From: [Cherry Diefenbach](#)
To: [Harris, Susan](#); [Koutoufidis, Nicholas](#); [Jacob, Dianne](#)
Subject: Comments on the JVR Energy Park (PDS2018-MUP-18-022) DEIR
Date: Wednesday, December 02, 2020 11:58:04 AM
Attachments: [Cherry Diefenbach's commnets on the jvr solar DEIR Dec 2, 2020.docx](#)

RE: JVR Energy Park (PDS2018-MUP-18-022) DEIR Comments

Visual Simulation of the Project

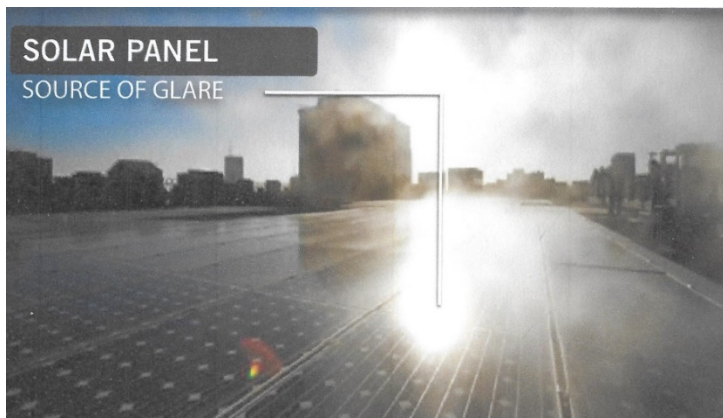
--A visual simulation of the tunnel-like view that east or westbound motorists travelling on Hwy 80, a county-designated scenic highway that runs through Jacumba would experience. The setback from right of way (ROW) north of Hwy 80 is 65 feet and the setback from the ROW

south of Hwy 80 is just 45 feet. The DEIR provides a misleading long-distance visual simulation from Airport Mesa looking west toward Jacumba that shows significantly wider setbacks along the south side of Hwy 80 and along the border fence. (See arrows in DEIR Figure 2.1-16 below.)

--A visual simulation of solar panels, three battery storage units, an inverter and a transformer on the low hill where vacant farm buildings are currently located. A six-foot high slatted fence at grade level along Hwy 80 will not adequately screen solar equipment from motorists or homes. (See 2019 photo of the project area including farm buildings, indicated with an arrow, as seen from a hillside location in town.) It is interesting to note that all those omitted visual simulations would show the project's most severe impacts to aesthetics. **Add additional visual simulations to the EIR as indicated above.**

Single Axis Tracker Behavior

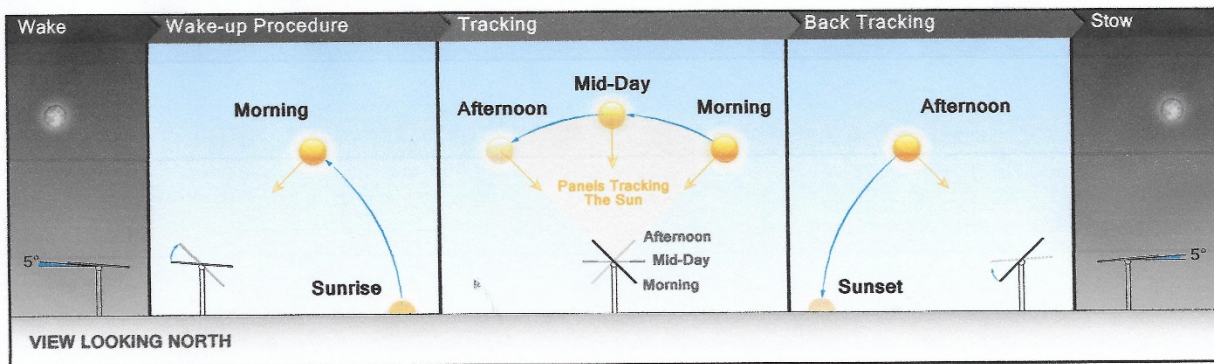
properties” (2.1-44). The project’s glare study also analyzed potential glare distractions to motorists and nearby structures based on a viewer height of 10 feet and then it erroneously concluded Jacumba residences would not be impacted by solar panel glare. The DEIR further states that the “5-degree wake/stow angles would cause any potential glare to be directed above and away from analyzed sensitive viewers residential locations and motorists on I-8, Carrizo Gorge Rd, and Old Hwy 80” (2.1.47). That statement doesn’t make any sense. The solar panels are in the wake/stow positions before they begin to track the east-west movement of the sun and also when the sun is directly overhead. (See Figure 6 from the glaze study below.)

Within the DEIR there is some confusion as to the orientation of the solar arrays. While the glare study describes an east/west tracking pattern for the solar panels, it also states “the solar facility would be directed southward toward the sun (2.6-35). **Clarify solar panel tracking and alignment.**
